SUBJECT: RESPONSE TO REQUEST FOR ADDITIONAL INFORMATION ON MIXING IN DOWNCOMER AND LOWER PLENUM (RAI 440.724)

NRI: REQUEST FOR ADDITIONAL INFORMATION

RAI 440.724:

FIGURE 440.724-1

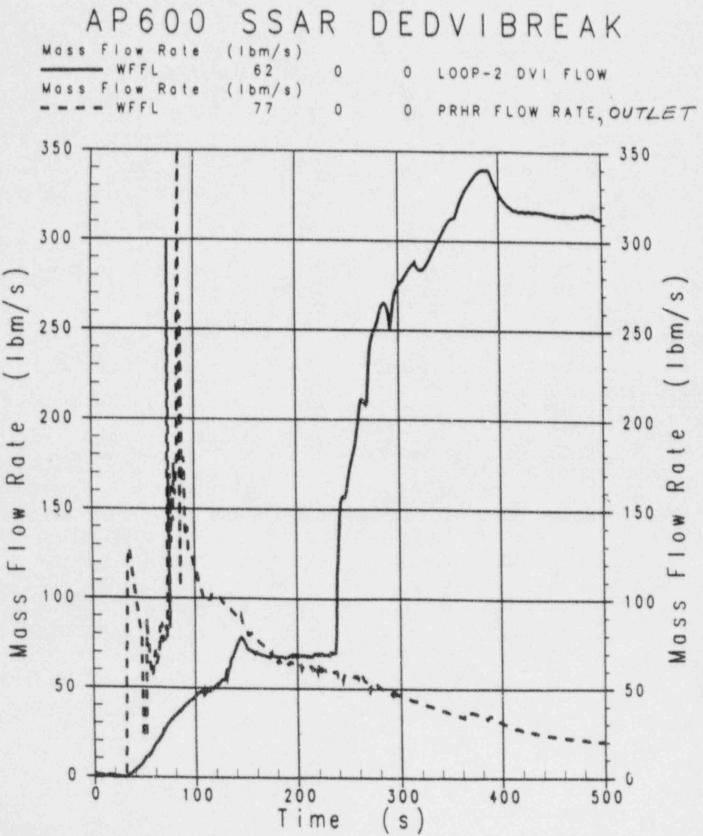
In the Westinghouse response to RAI 440.120 dated May 14, 1997, Westinghouse stated that "the relatively low flow rate of fluid from the downcomer into the core during post-RCP trip natural circulation phase of AP600 small break LOCA events enables mixing to occur in the core and lower plenum. No unmixed slugs of highly dilute liquid from the PRHR are present in the downcomer to enter the core during the LOCA design basis scenarios." Please provide quantitative technical justification to support engineering judgement regarding mixing in the downcomer and the lower plenum of the core. The justification should include break size (worst case scenario), as well as condensate flow rate and final boron concentration(s). The boron concentration and concentration uniformity in the downcomer should also be addressed.

The mixing which occurs between the dilute plume and the downcomer liquid has been calculated using the method of Reference 440.724-2, applying the analogy between heat and mass transfer. Based on the conditions predicted to exist in the downcomer in the SSAR DEDVI break NOTRUMP analysis, a Froude number is computed for the plume. The degree to which the boron content of the plume approaches the 1860 ppm surrounding concentration is then calculated in the same way that the density profile is calculated in Reference 440.724-2. The average boron concentration within the plume is calculated to be 1290 ppm at the bottom of core barrel elevation. Since the plume will undergo internal mixing and mix further with the surrounding liquid after it contacts the reactor vessel bottom surface in the lower plenum and is redirected to flow upward to the core inlet, the use of the plume average boron concentration is a reasonable approximation of the minimum boron content of the liquid entering the core.

Reference 440.724-3 states that a boron concentration of 1200 ppm is adequate to prevent a return to critical in the fluid tempe. "ture range which prevails during the 170-240 second time interval of the DEDVI break transient. The DEDVI case during this time interval represents the limiting case scenario for potential boron dilution associated with the APE00 small break LOCA analysis. After 240 seconds of the DEDVI break transient have elapsed, the intact accumulator injects a large flow of highly borated (2600 ppm) safety injection water into the downcomer, increasing the ambient boron concentration above the 1820 ppm value. Also, the PRHR condensation rate diminishes as shown in Figure 440.724-1. Therefore, the potential for boron dilution diminishes as the DEDVI transient proceeds beyond the time period analyzed above, during which the minimum boron concentration is adequate. Also, the boron dilution calculated for Case A above is more favorable (at >1300 ppm boron concentration in the dilute plume region) than is true for the DEDVI break scenario.
